**Remedial Investigation and Removal Action Work Plan for
Riverside Park – Draft RI Results Addendum
Libby Asbestos Site, Operable Unit 4**

September 26, 2003

9/24/03
Jim -
Here's a copy of the draft
Riverside Park workplan
addendum for your
over-the-shoulder review.
There are a couple of formatting
things that still need to be
done.
Geoff

Figure 2-2
Sample Location Map
Riverside Park
Libby, Montana

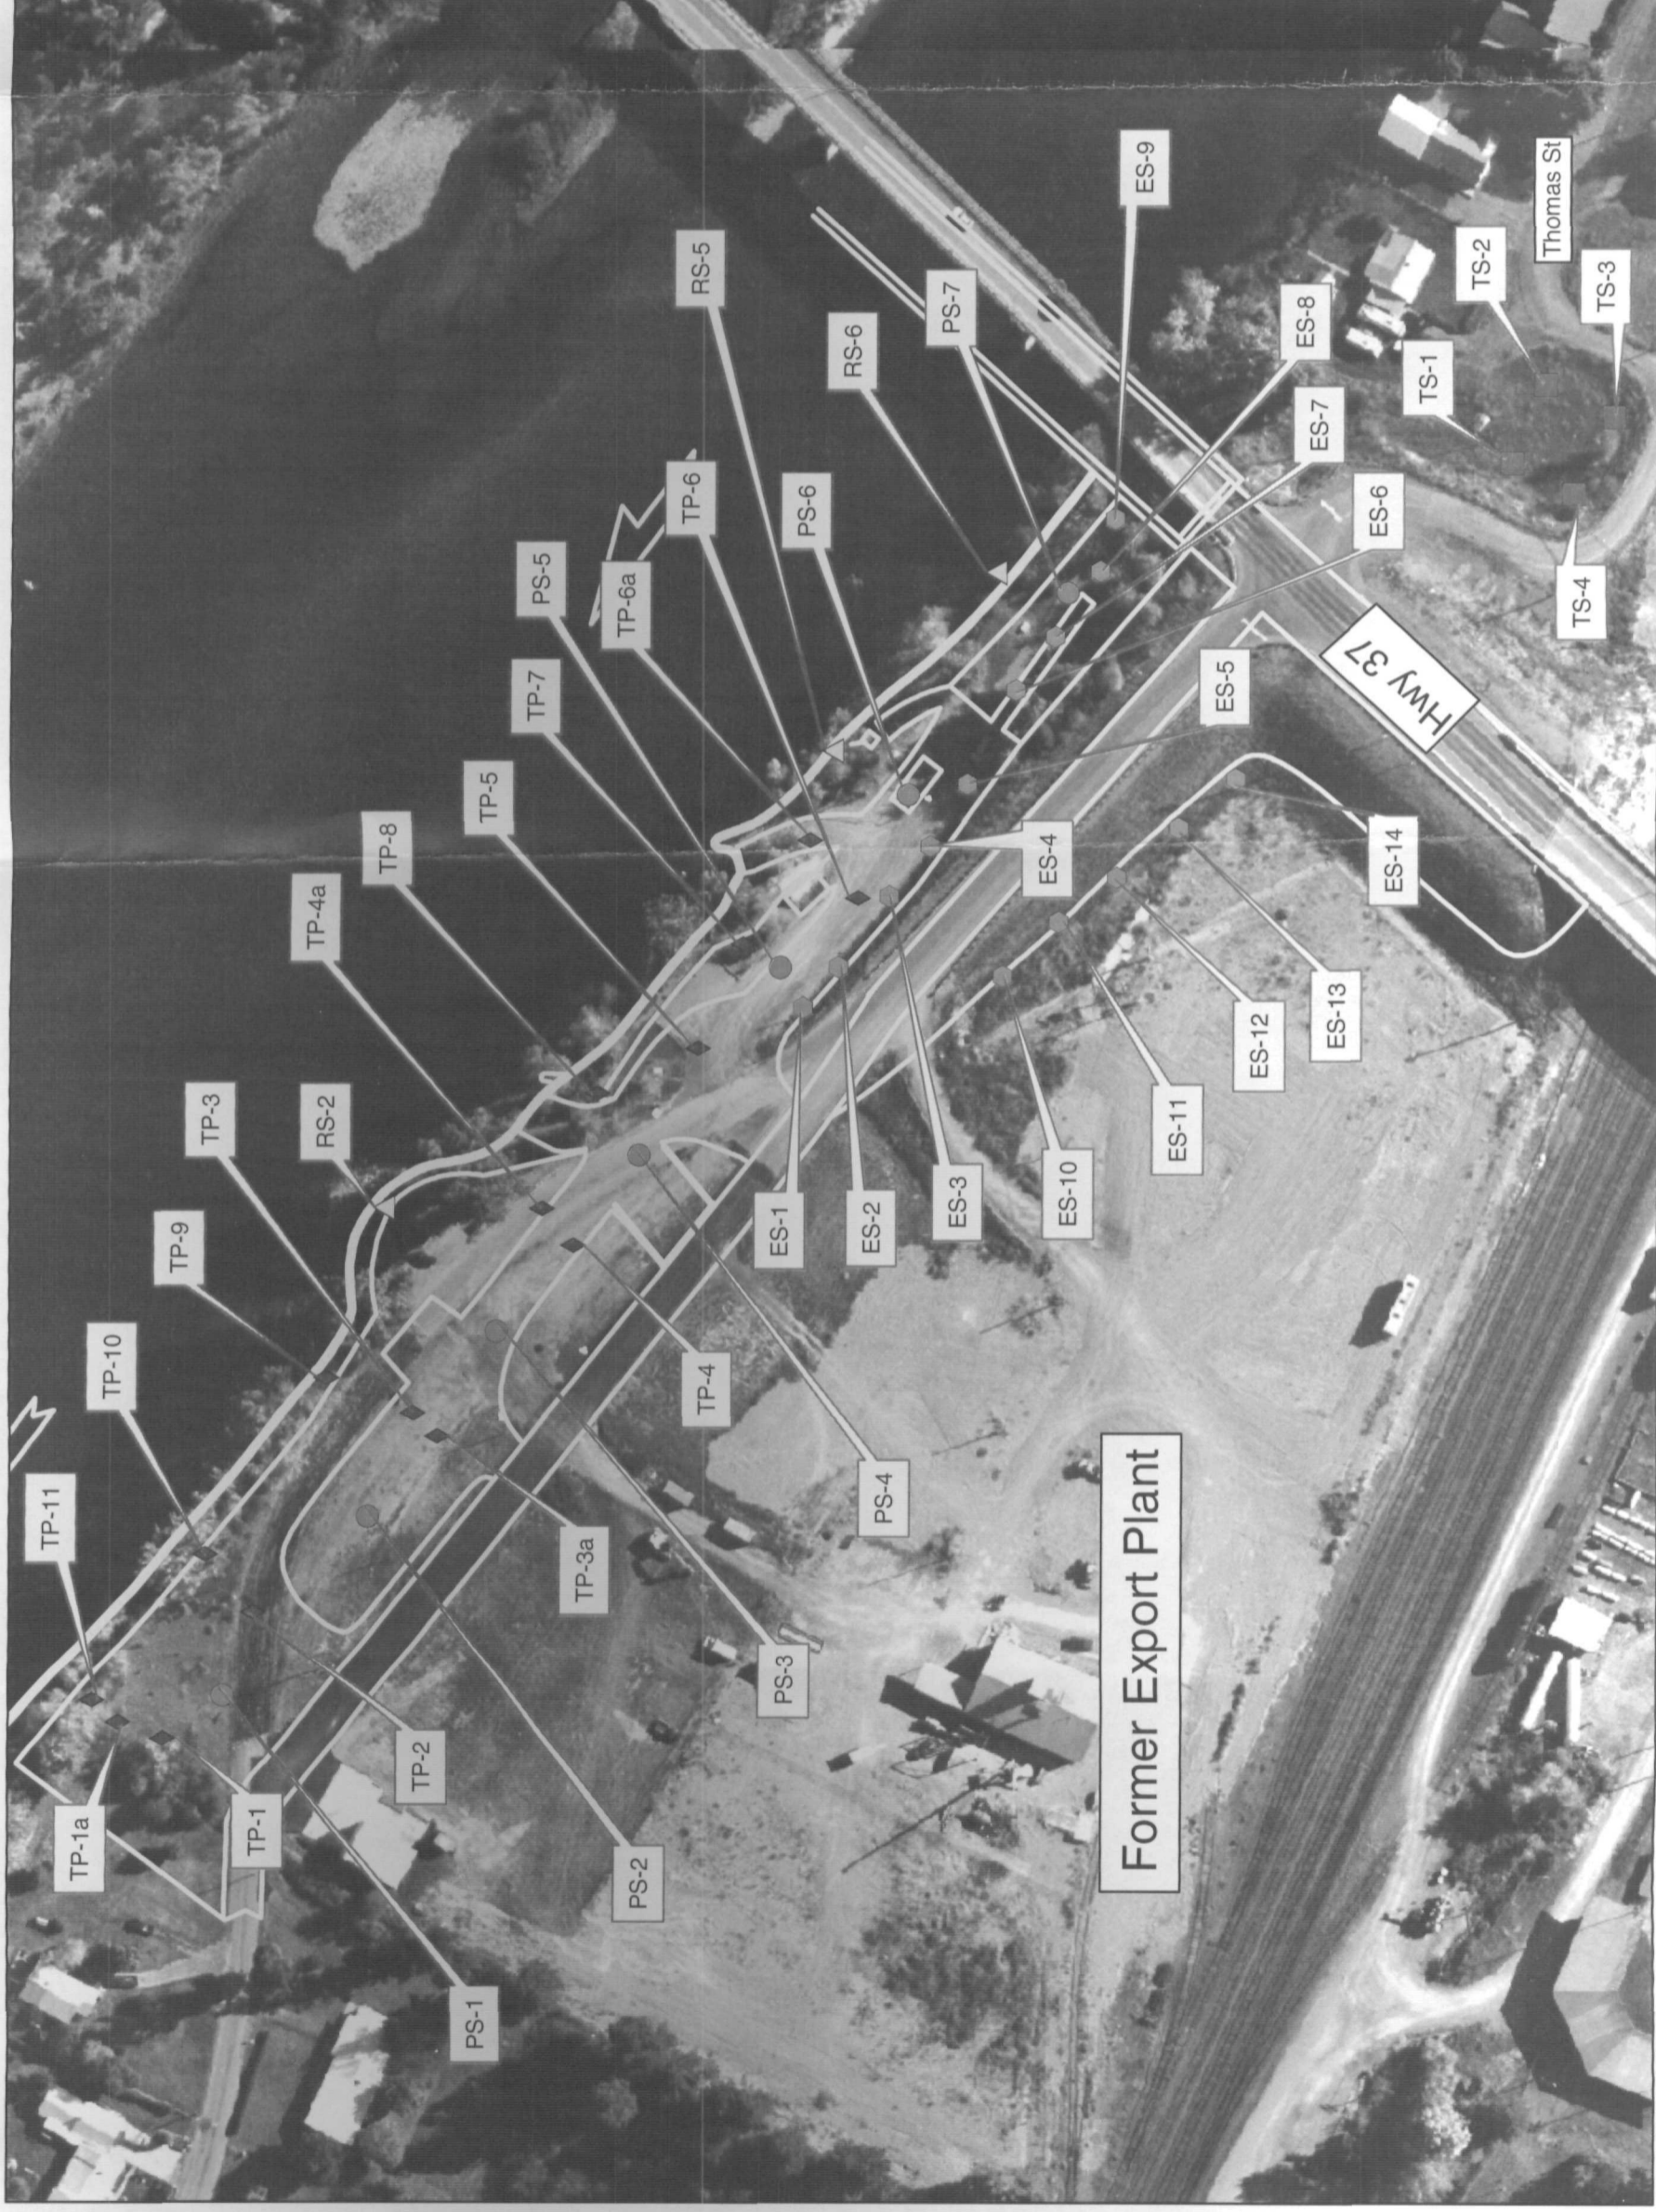
*why is scale different than other
figs, 2*
